Amendment 0001
Solicitation Number: ONRBAA11-028
“Large Displacement Unmanned Underwater Vehicle Innovative Naval Prototype (LDUUV INP) Energy
Section Technology”
Date: (4 AUG 2011)

The purpose of Amendment 0001 is to amend the BAA and respond to questions submitted prior to 10 AUG 2011. Enclosure Number 1 to Amendment 0001 entirely replaces/supersedes the original ONR BAA 11-028 previously posted.

Large Displacement Unmanned Underwater Vehicle Innovative Naval Prototype (LDUUV INP) Energy Section Technology

Figure 2: Threshold Mission Profile
(Data available in Appendix A)

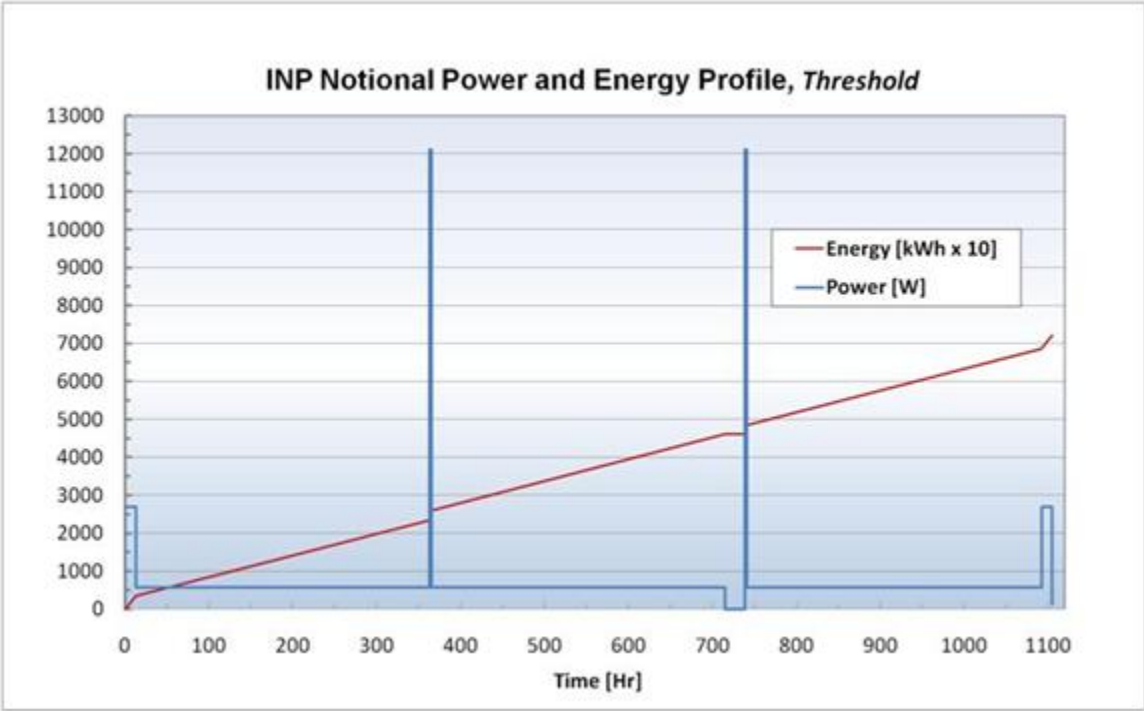
Table 4, page 7 of ONR BAA 11-028, states an 8 kW battery would be available on-board the LDUUV; while in Figure 2, page 5, states a peak power of 12 kW is required. Is the 12 kW of power required in addition to the available 8 kWh battery? Or can the energy section supplement the battery to provide a full 12 kW to the LDUUV?

For the purposes of the UUV Energy Section, the 8kW battery may only be used for startup (for up to one hour). The threshold and objective power and energy profiles must be met solely by the energy section.
